Dolby Laboratories Inc

Field Bulletin 200

Model CP500 Random Clicking Noises or High Hiss Level Cat. No. 681 Digital Audio Clock Circuit

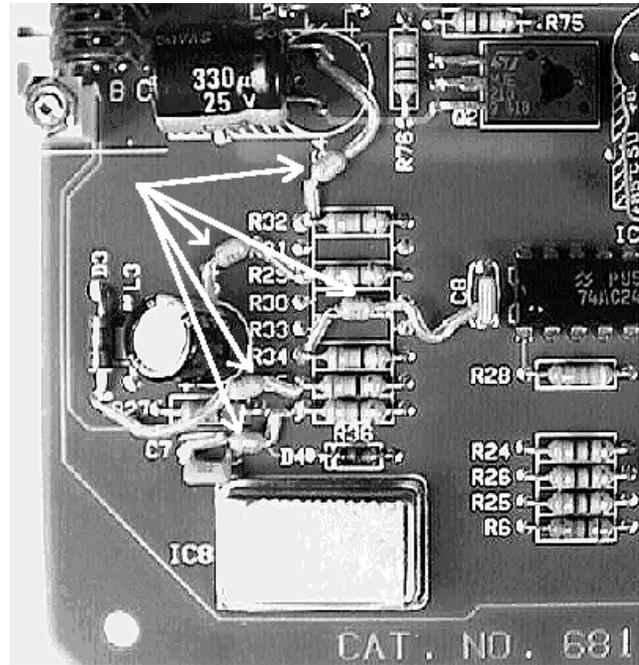
2. Looking at the board with the component side towards you and the connector on the left, find the small metal can at the lower left corner. Directly above this is a column of five resistors. The components to be replaced are designated R32, R29, R34, R35, and R36. Note that there are three empty component positions (R30, R31, and R33). This is intentional and these positions should remain empty.

Note: The original resistors and the new inductors are similar in shape:

The **resistors** contain a blue and a gray color band.

The **inductors** contain a brown and a green color band.

NOTE: On some versions of this card, you will find small ceramic capacitors connected to one end of some resistors you are replacing. Be sure that they are re-connected as you replace the resistors with inductors as shown.

De-solder and remove each resistor and replace it with a 0.15 microhenry inductor (Dolby Part Number 14086 available at no charge from Dolby offices). The inductors will fit correctly in the spaces vacated by the resistors.
